AP1000 DESIGN CERTIFICATION REVIEW

Response to Request For Additional Information

RAI Number: 440.100

Figure 440.131-1: OSU Test SB18 ADS-4 IRWST Initiation Phase
Upper Plenum Collapsed Levels (Relative to Bottom of Lower Plenum)

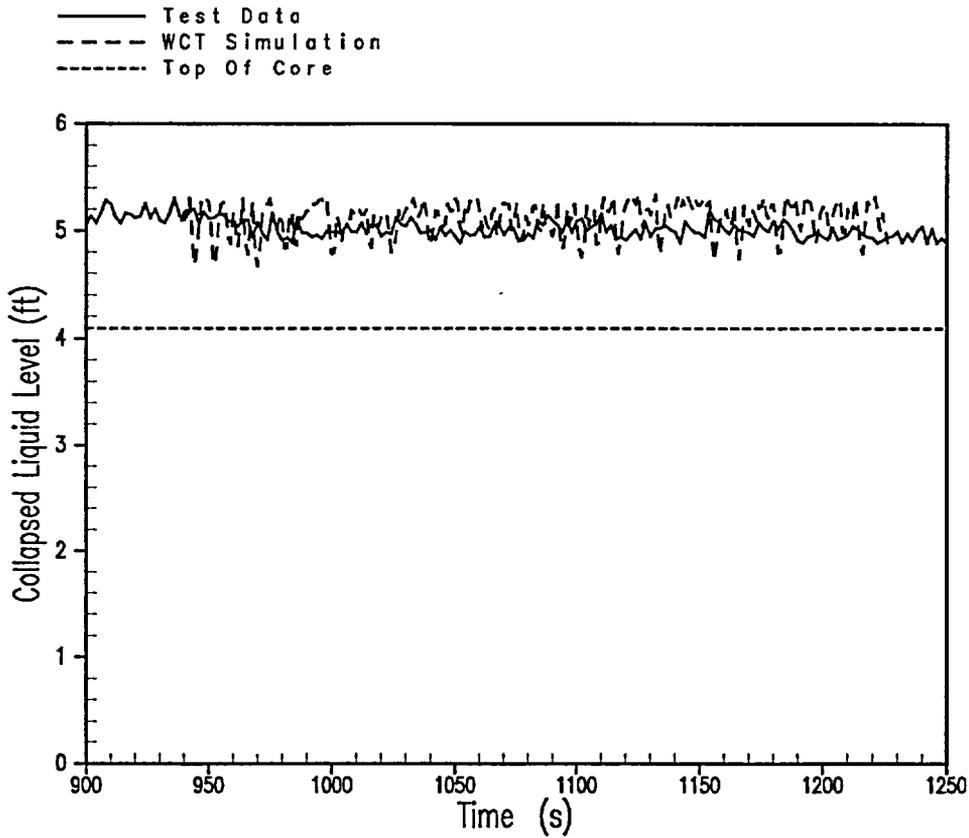
Figure 5.1.2-4 of WCAP-14252 provides upper plenum void fractions for OSU test SB18. Please provide the corresponding predictions of upper plenum void fractions from WCOBRA/TRAC.

Figure 5.1.2-4 presents a simple translation of the Test SB18 measured collapsed liquid levels into steam percentages, as indicated by the title line "based on indicated level channels." This figure does not indicate two-phase mixture void fractions in the upper plenum, and it does not correspond to the WCOBRA/TRAC-predicted mixture void fractions in the upper plenum channels.

Since Figure 5.1.2-4 does not contain any additional information to that available from a liquid level comparison, it is more straightforward to compare levels directly. The attached figure is Figure 2-33 from WCAP-15833, but with the Test SB18 data for upper plenum collapsed level (relative to the bottom of the lower plenum) superimposed. The level predicted by WCOBRA/TRAC inside the core barrel shows reasonable agreement with the Test SB18 test data.

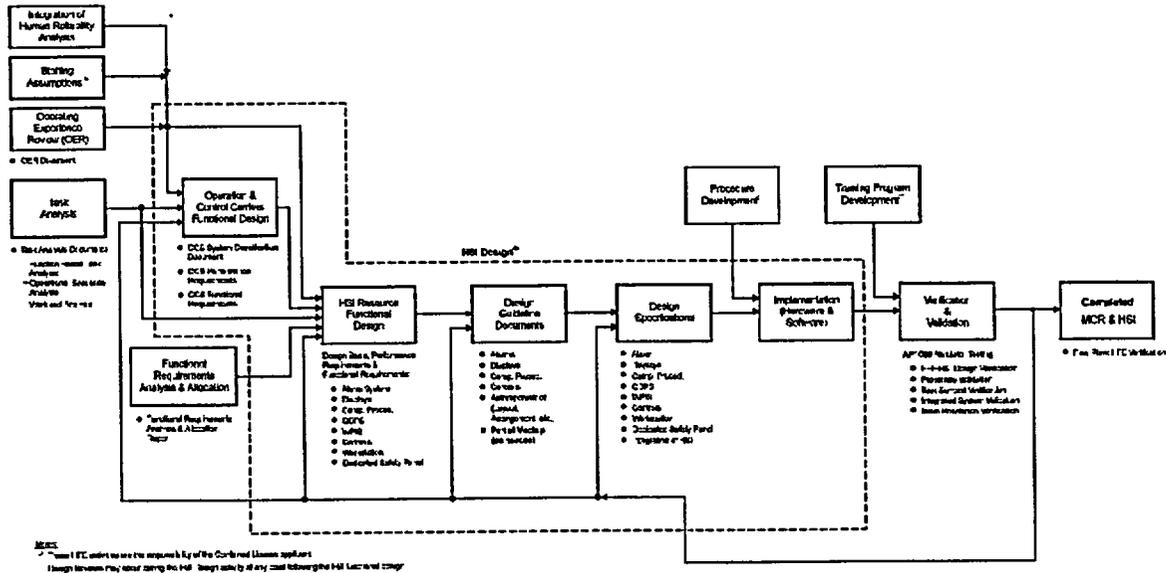
DCD Rev. 1, page 18.2-21, Figure 18.2-3. The figure should be modified if it is to remain in agreement with current NRC guidance, NUREG-0711, Rev. 1, May 2002. In addition, please provide the basis for all changes made to the HFE process from the process approved for the AP600 design.

An activity block corresponding to DCD Section 18.14, "Human Performance Monitoring", will be added to Figure 18.2-3 to satisfy NUREG-0711 Rev 1. See also responses to RAIs 620.008 and 620.018.

Figure 720.009-1
MAAP4 vs. NOTRUMP PRHR Heat Removal (AP1000)

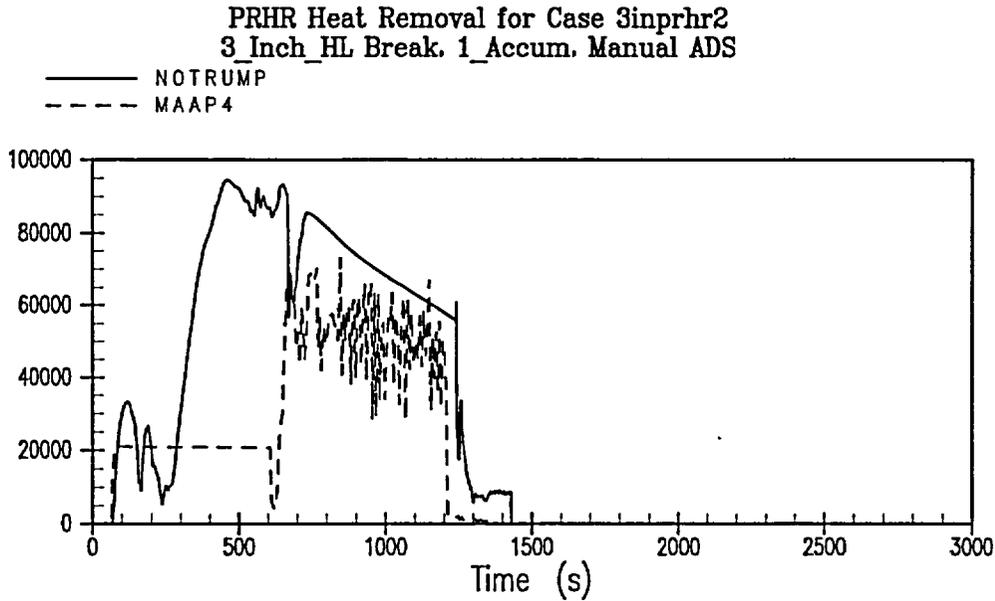
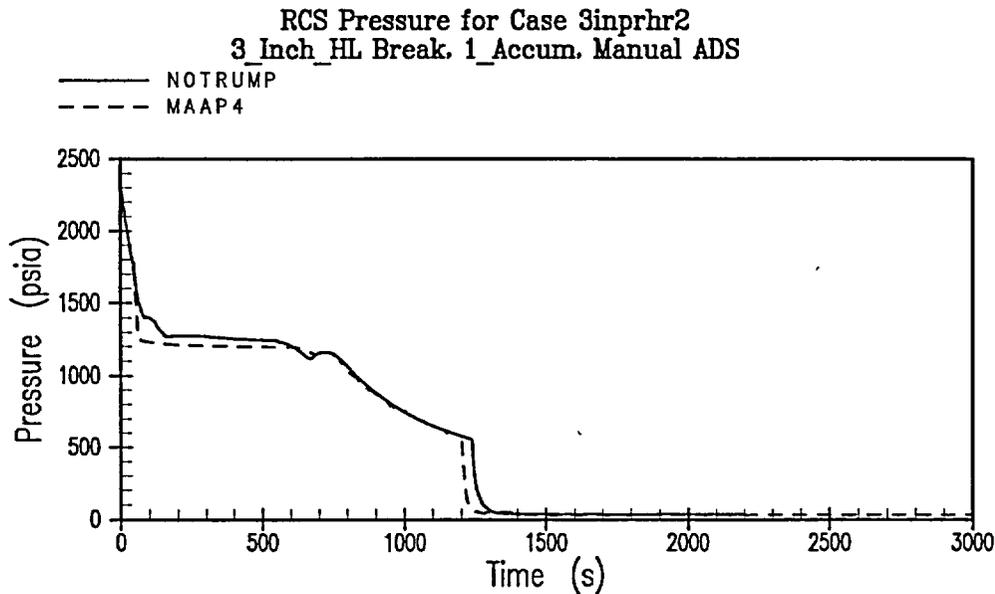
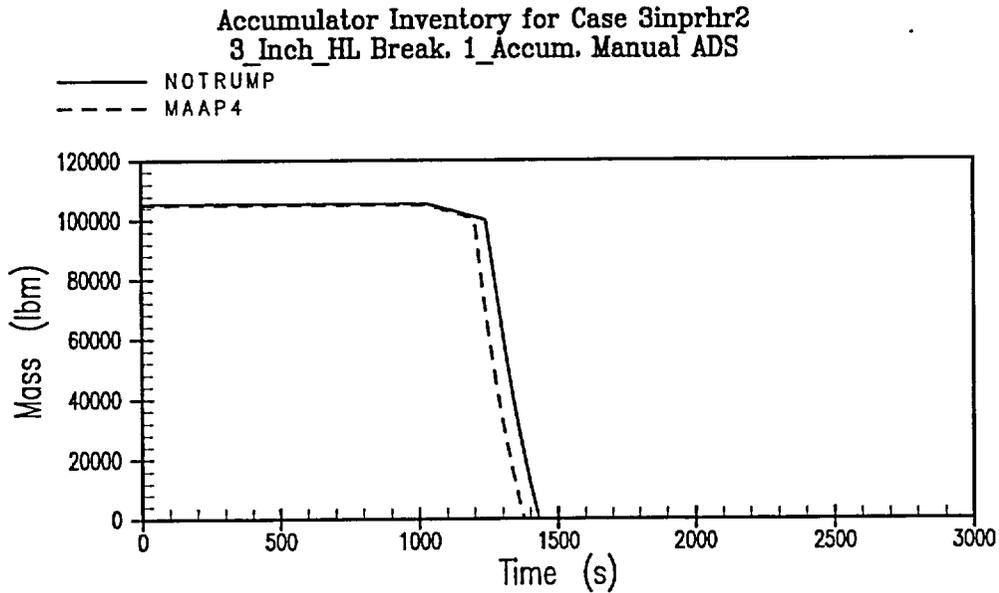
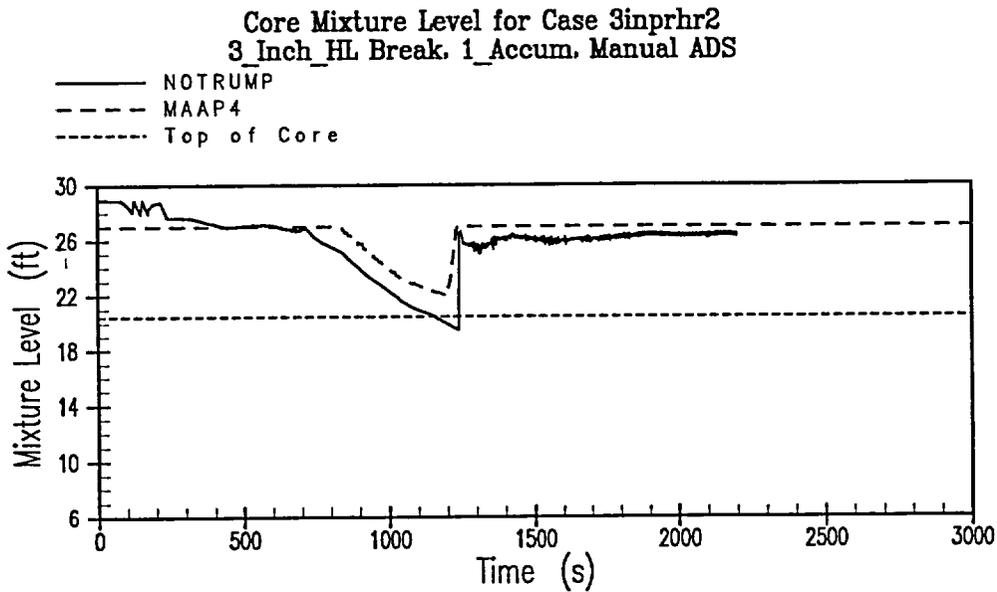
- B. Credit for the PRHR HX is stated to be required for some of these breaks, mainly between approximately 3 inches and 4 inches. In evaluating experimental data from the PRHR test facility, the nucleate boiling heat transfer correlation used in NOTRUMP was evaluated and found to produce heat fluxes that were too high in comparison to the data as the PRHR heat load increased. See Section 1.11 of WCAP-14807, "NOTRUMP Final Validation Report for AP600." Please provide analysis for the equipment operability assumptions listed in Section A.3.3.1 and Cases No. 1 and No. 2 in Section A5.1 showing that success will still be obtained if a PRHR HX correlation is used that matches experimental data.

- (B) The analysis reported in PRA section 3.3.1 was performed with MAAP4. For the medium LOCA success criteria analysis the MAAP4 PRHR HX performance was compared with the NOTRUMP PRHR HX performance for a 3" HL LOCA. Figure 720.009-1 shows that the

MAAP4 PRHR HX removes a similar, but smaller amount of heat from the RCS as a function of pressure. Figure 720.009-2, -3, -4 show the resulting RCS pressure, accumulator mass and core mixture level calculated by MAAP4 and NOTRUMP. These parameters are very similar between the two.
